DPR 25-21: Mo' Bettahs

Planning & Building Department Staff Report

For Hearing on January 26, 2026

A. PETITION NUMBER	DPR 25-21: Mo' Bettahs
B. APPLICANT	Savory MB Stores LLC, c/o Will Scott, PGAL
C. LOCATION	8894 East U.S. Highway 36, Avon IN 46123 Lot 5 in Harvest Landing

Exhibit C – Proposed Site Plan

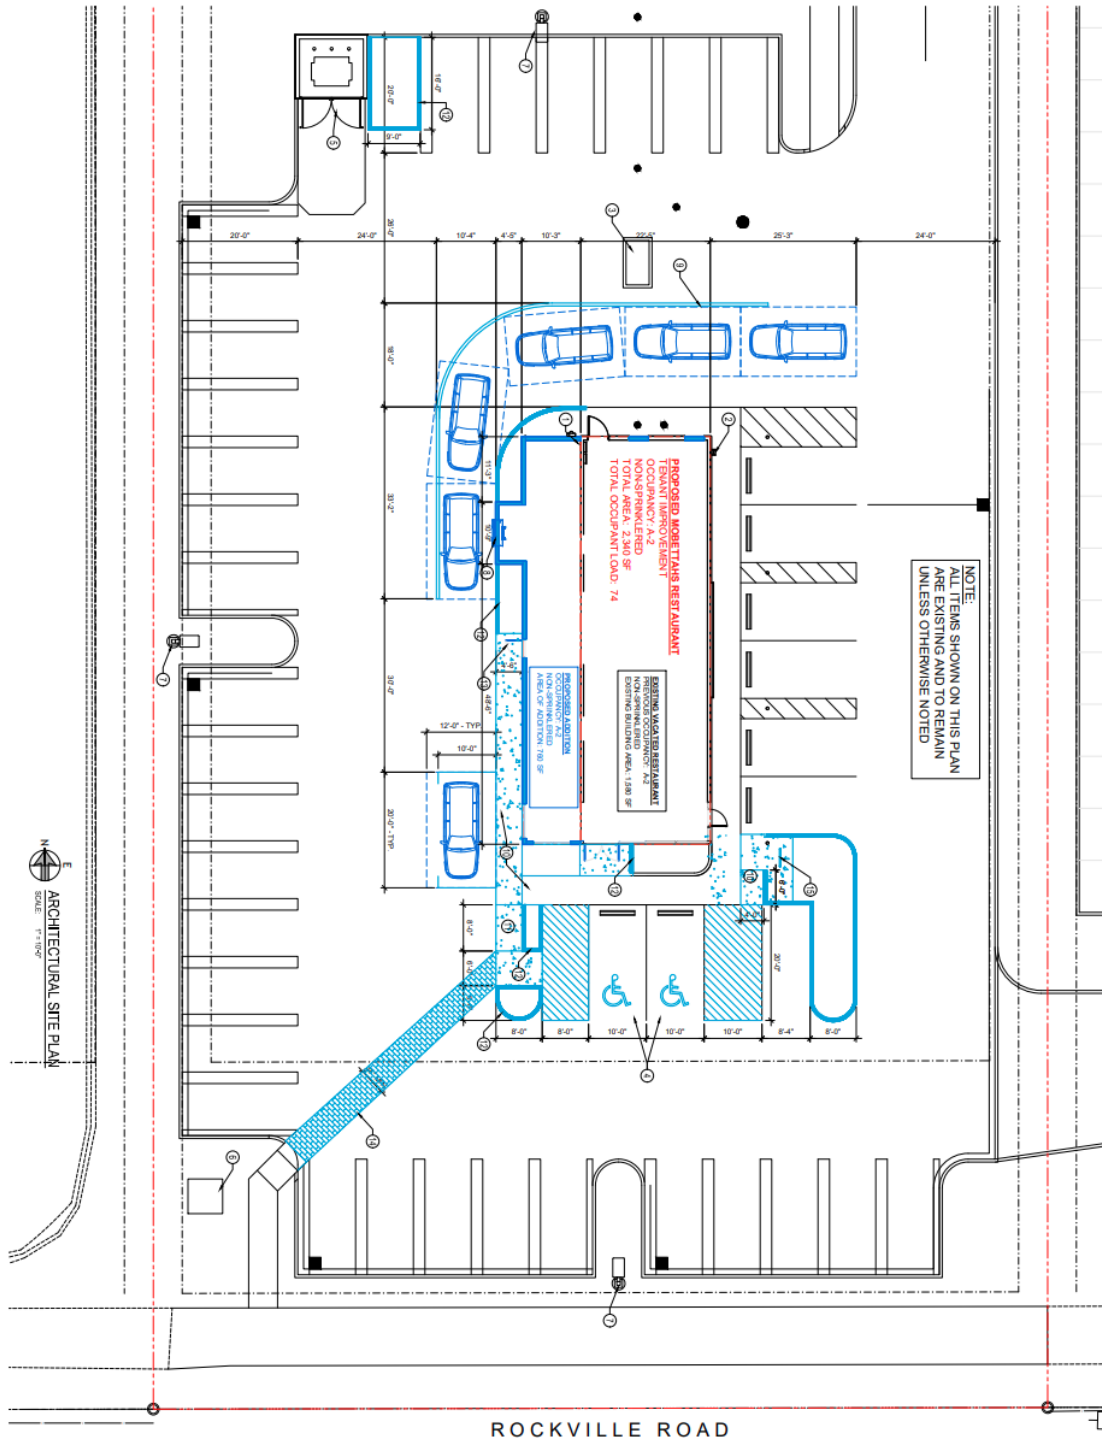
a) **Parking:** The revised plans indicate forty (40) parking spaces (two ADA spaces). The UDO requires a minimum of five (5) spaces 1,000 square feet for restaurants, which would require a minimum of twelve (12) spaces. The UDO requires a minimum of two accessible (ADA) spaces when between 26 and 50 total spaces are provided.

c) **Bicycle Parking:** The UDO requires one bicycle rack per every twenty (20) required vehicle parking spaces. While a bicycle rack exists on site, a compliant rack nearer to the public entrance of the renovated building has been proposed.

No changes to the site's vehicular access are proposed. The site is connected via walkway to the public sidewalks along the two abutting streets, and the revised site plan will increase compliance with the UDO's pedestrian network standards by including an internal pedestrian crosswalk with a contrasting surface material connecting the building to the asphalt path adjacent to U.S. Highway 36.

Exhibit D – Proposed Landscape Plan

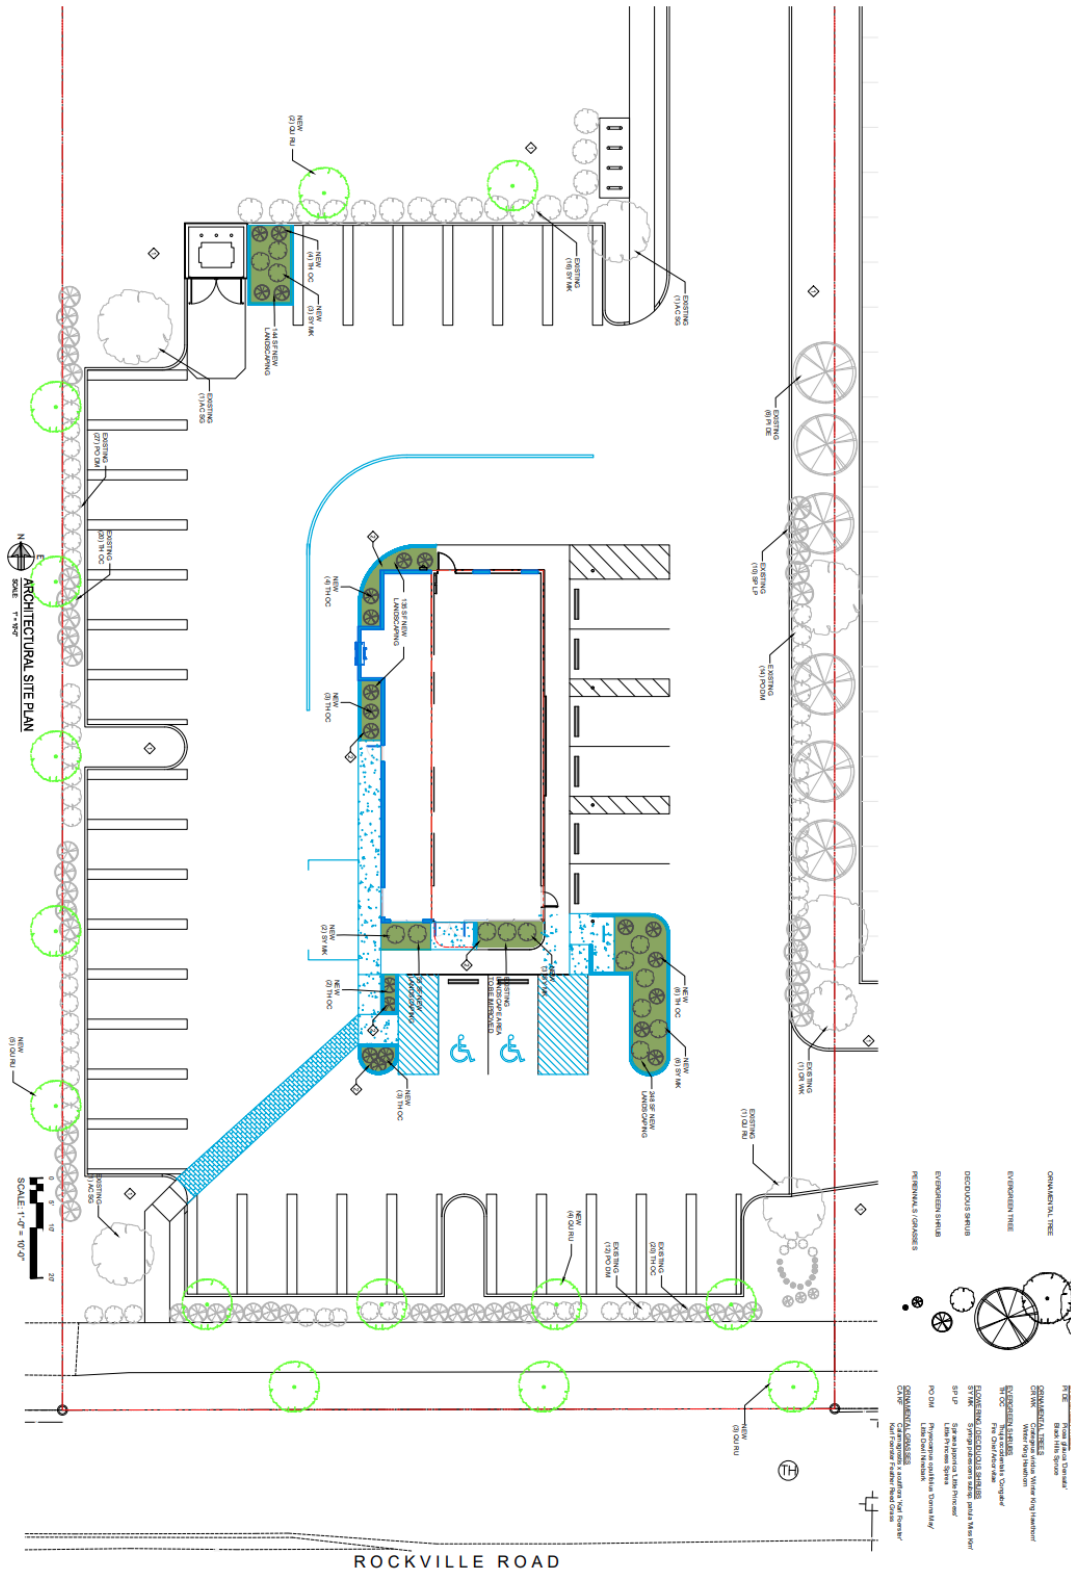
The revised landscape plan, submitted subsequent to the Technical Advisory Committee (TAC) meeting, addresses staff comments requesting additional tree plantings along the site's U.S. Highway 36 frontage and the west perimeter of the parking lot, terminal islands on each end of the parking row adjacent to the south façade, and additional foundation planting areas. It appears that additional landscaping should be included north of the trash enclosure to screen it from Harvest Landing Drive as required by UDO 5.1(H)(1).

Exhibit E – Existing & Proposed Building Elevations (South & North)

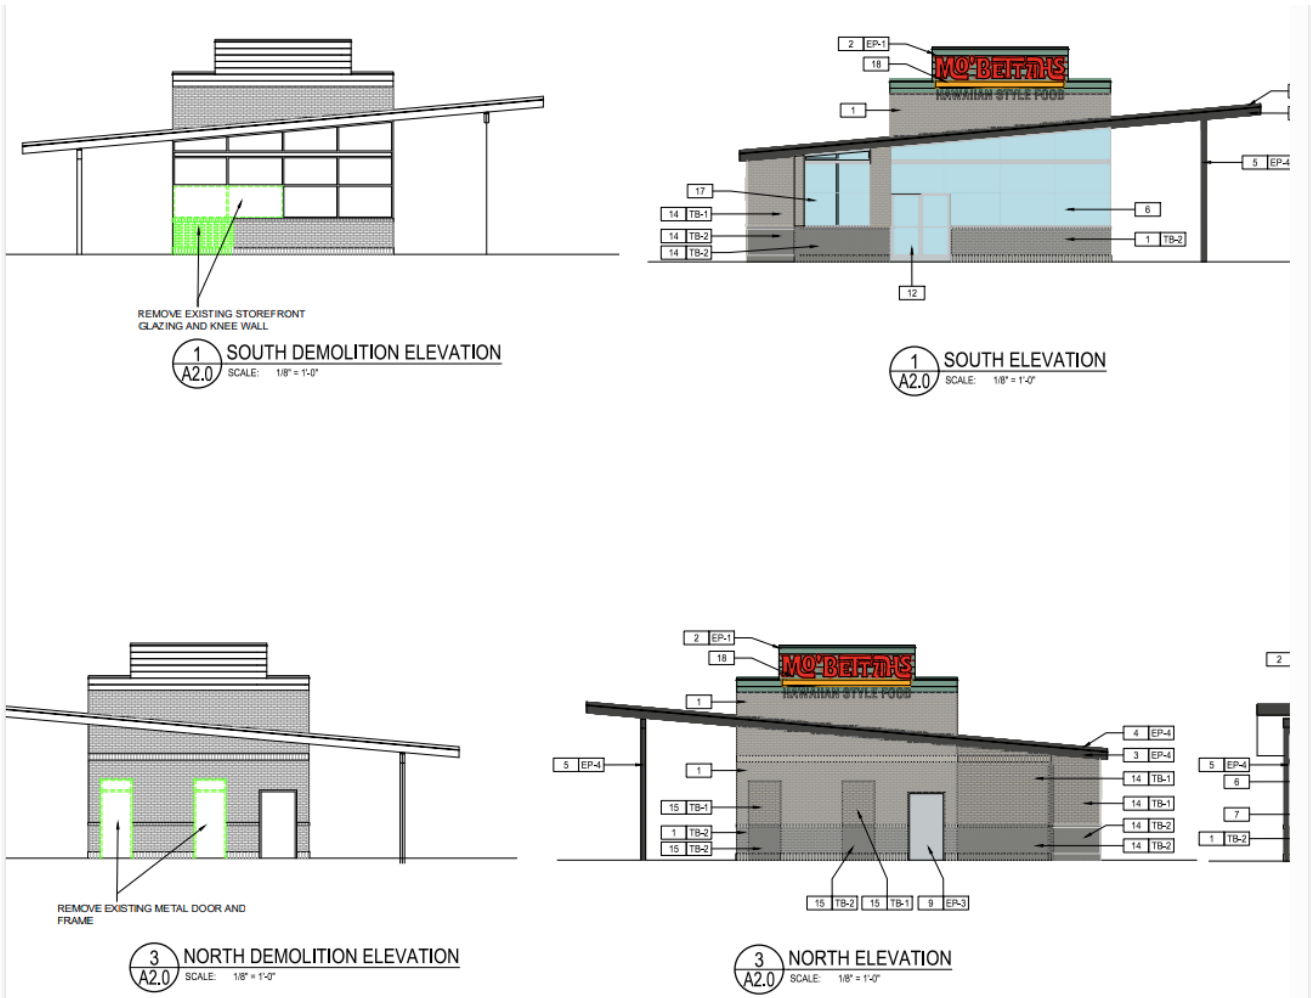
The revised building elevations submitted subsequent to TAC review appear to meet both the general architectural standards of UDO 7.10 as well as the additional U.S. Highway 36 overlay requirements found in UDO 2.10(O), except for the waiver for use of "thin brick", which is addressed below.

Waiver of Design Standards of UDO 7.10(l)(1), to allow for the use of “thin brick” siding (brick less than four inches thick not permitted).

“Thin brick” was not a prohibited material when the building was approved in 2022. Using additional thin brick to match the remainder of the existing building which is now legally nonconforming should not harm the public or adjacent properties.

Staff agrees that matching the existing exterior material is reasonable and preferable to using a permitted material that might not blend well aesthetically, and that it would be unreasonable to expect the petitioner to replace the existing siding material that is only a few years old.
